## Addendum No. 2

Solicitation Number: *FY23-ITBCON-35*

Title: *Franklin Water Treatment Plant Clearwell Improvements*

FRANKLIN WATER TREATMENT PLANT  
CLEARWELL IMPROVEMENTS

YARD PIPING  
CIVIL  
ENLARGED SITE PLAN - AREA 1

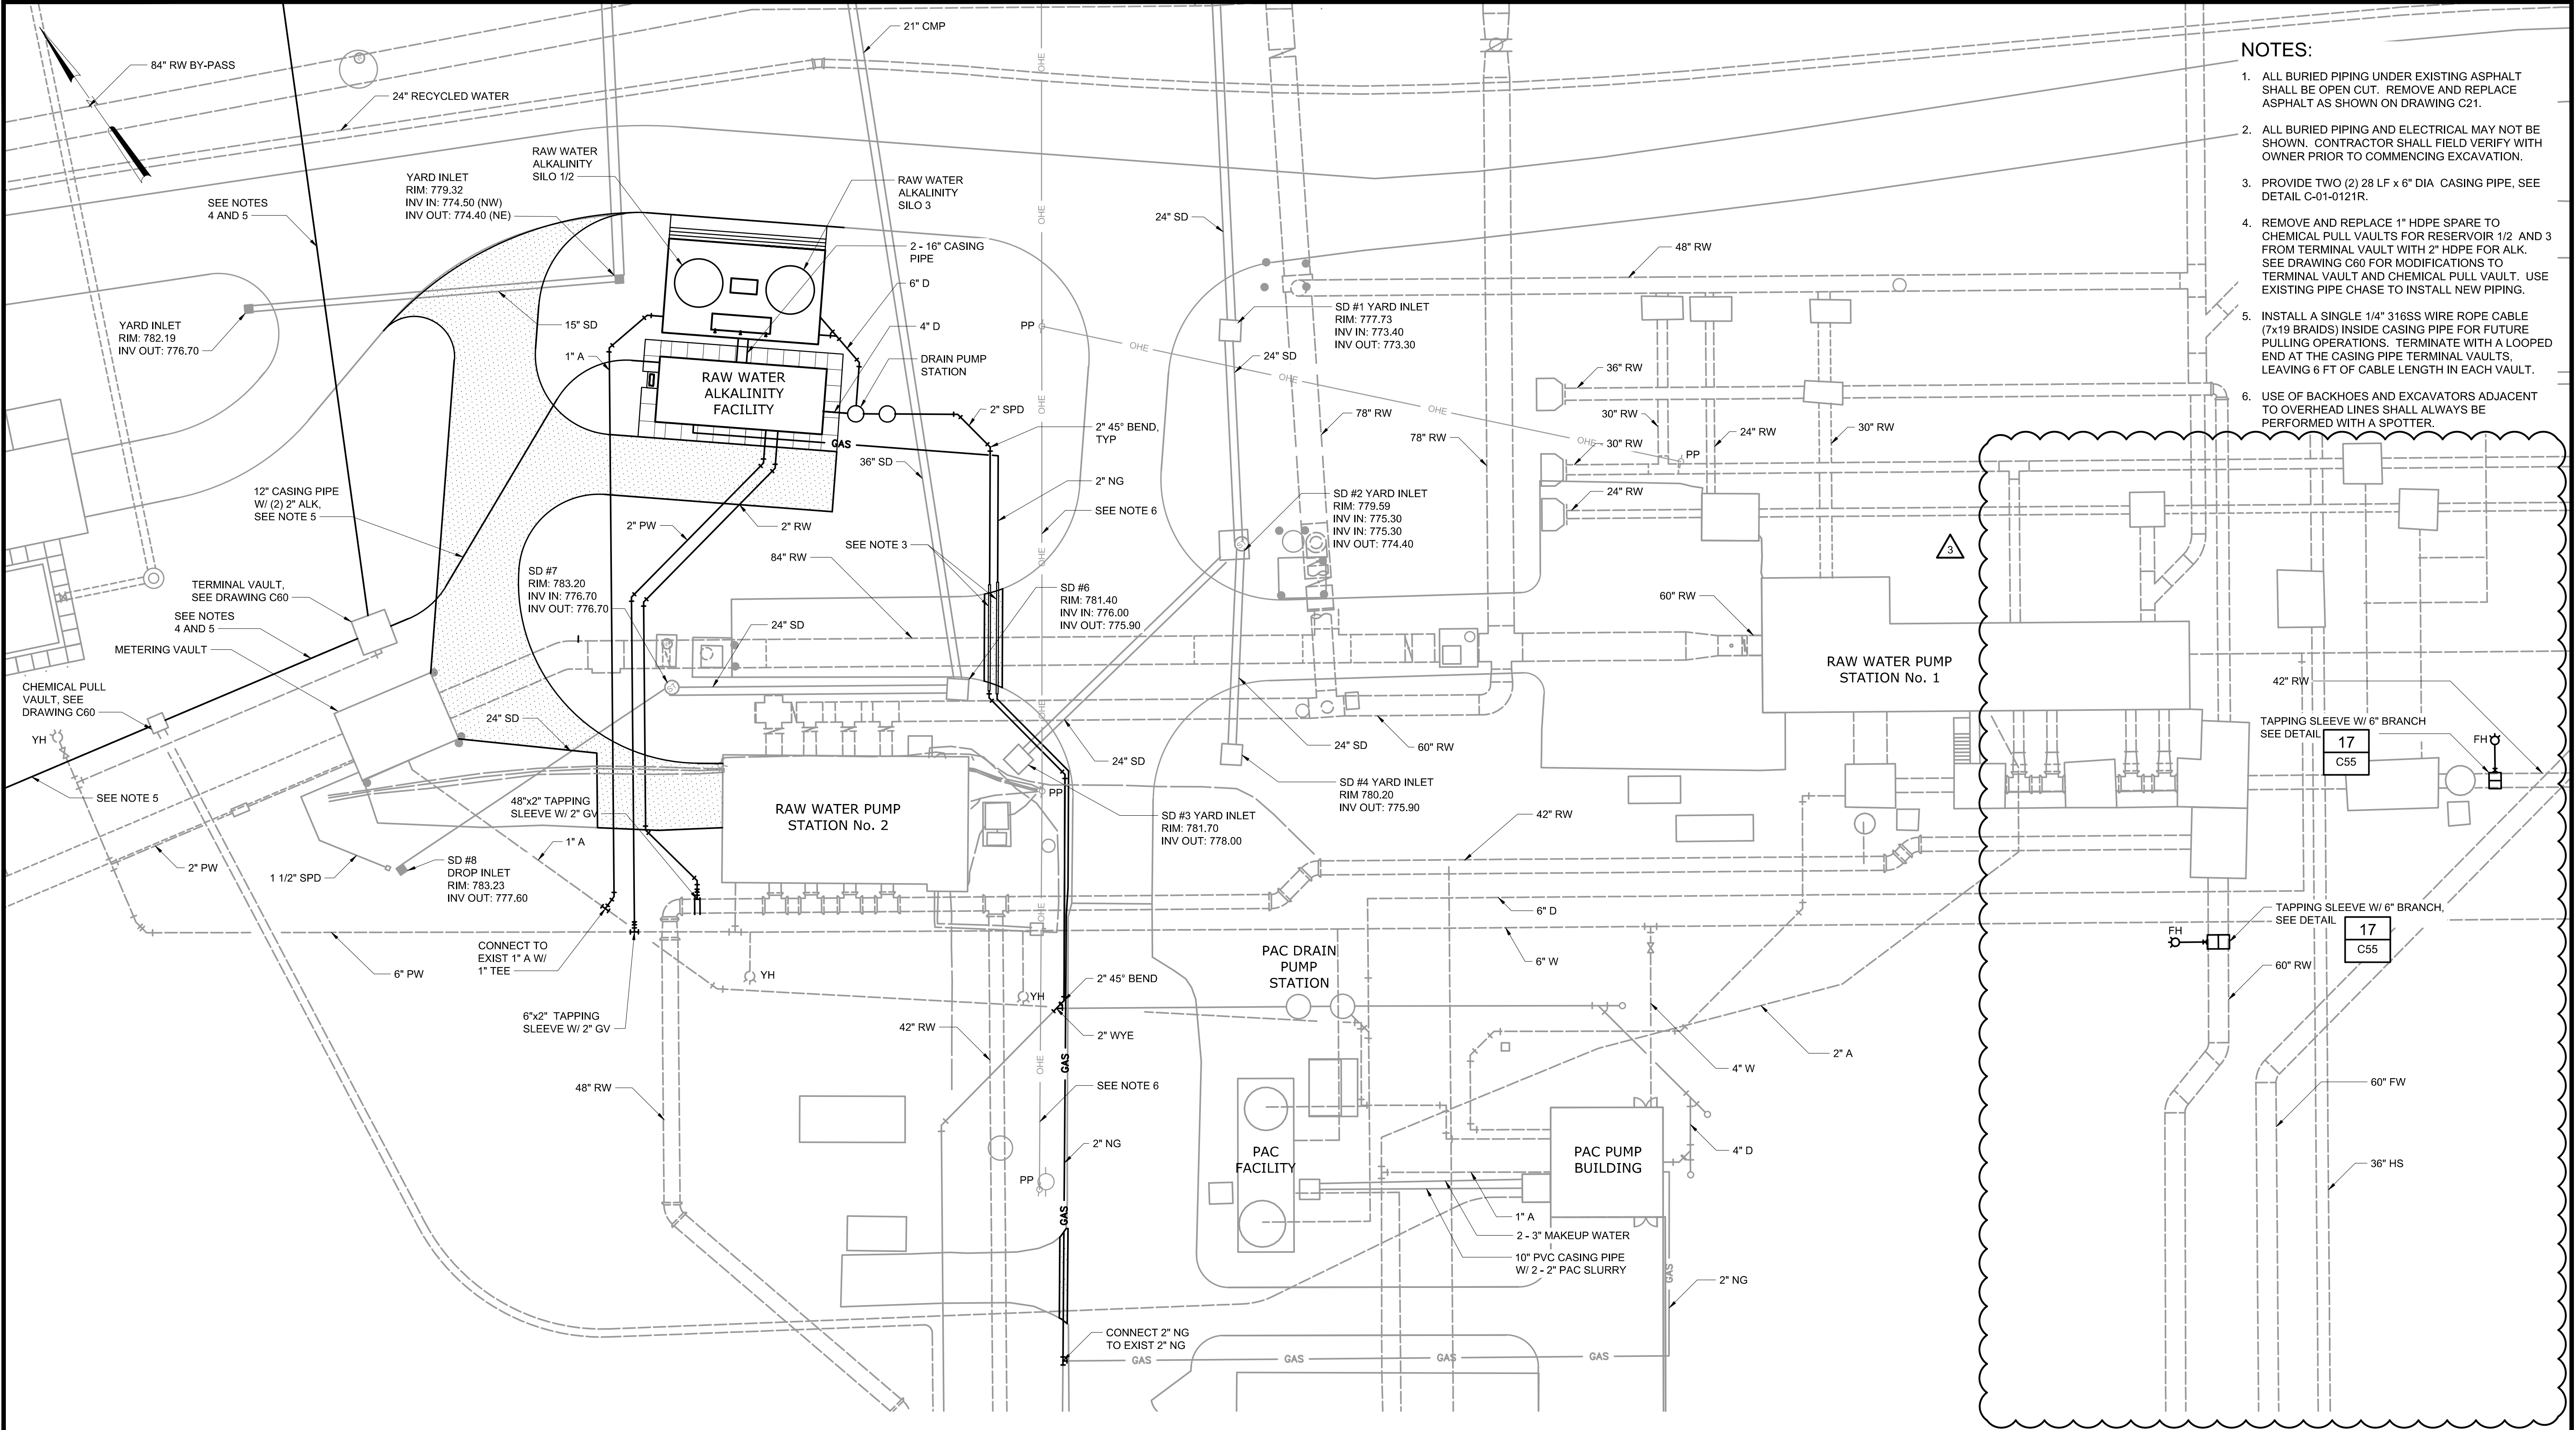
#	Contract Sheet # and Title	Revision #	Modification
1	G2, General Abbreviations and Legend	Revision No. 4	In the NOTES section, <b>add</b> the following note:  "3. The Owner will permit the Contractor to use the 3-ton monorail crane in the Control Building basement provided it is operated by a qualified individual. Any damage to the crane or monorail resulting from the Contractor's use shall be repaired at no cost to the Owner."
2	C41, Yard Piping Civil Enlarged Site Plan – Area 1	Revision No. 3	<b>Replace</b> Contract Drawing C41 in its entirety with the attached Contract Drawing C41. The Contract Drawing has been revised to show two new fire hydrants connected via tapping sleeve to existing raw water lines.
3	C55, Yard Piping Civil Details	Revision No. 3	<b>Add</b> the attached Detail 17 to Contract Drawing C55.
